Access Compliance Report

Public Rights-of-Way

Intersection ID: 10035520	Main Street: REA_RD	Cross Street: N/A	Location: SW
ADA ID: A56B2046F59C	Ramp Type: PerpDiag	Initial Pass/Fail: Fail	Overall Compliance: No
Severity Score: 13.75			
Codes/Mitigation Info/Possible Solution		Field Measurements/Component Compliance

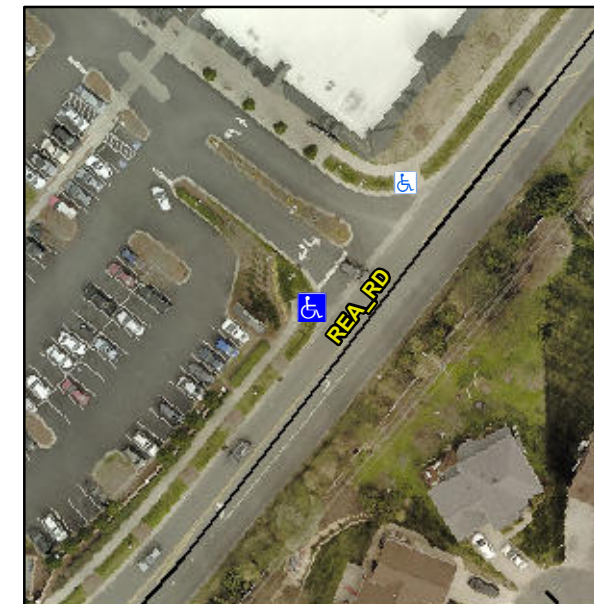
Not Found, R304.2.2, R304.5.3

Compliance	Description	Data	Compliance	Description	Data
N/A	Ramp Length (in)	99.0	No	Ramp Slope (%)	8.5
Yes	Ramp Width (in)	48.0	No	Ramp XSlope (%)	2.1
N/A	Flare Type LT	N/A	N/A	Flare Type RT	N/A
N/A	Flare Slope LT (%)	N/A	N/A	Flare Slope RT (%)	N/A
N/A	Flare Traversable LT?	N/A	N/A	Flare Traversable RT?	N/A
N/A	Landing Length (in)	N/A	N/A	DWS Provided?	N/A
N/A	Landing Width (in)	N/A	N/A	DWS Contrast?	N/A
N/A	Landing Slope (%)	N/A	N/A	DWS Length (in)	N/A
N/A	Landing X Slope (%)	N/A	N/A	DWS Full Width?	N/A
N/A	Landing Curb? (Y/N)	N/A	N/A	DWS Offset (in)	N/A
N/A	Shared Landing?	N/A			
N/A	Gutter Ponding?	N/A	N/A	Gutter Slope (%)	N/A
N/A	Gutter Lip Ht (in)	N/A	N/A	Gutter X Slope (%)	N/A
N/A	Painted X Walk1?	No	N/A	Painted X Walk2?	No
	X Walk 1 Direction	To SE		X Walk 2 Direction	To NE
N/A	X Walk 1 Width (in)	N/A	N/A	X Walk 2 Width (in)	N/A
	X Walk 1 Slope (%)	2.0		X Walk 2 Slope (%)	1.8
	X Walk 1 X Slope (%)	1.1		X Walk 2 X Slope (%)	3.3

Remove & Replace Curb Ramp With Two New Directional Ramps or Equivalent.
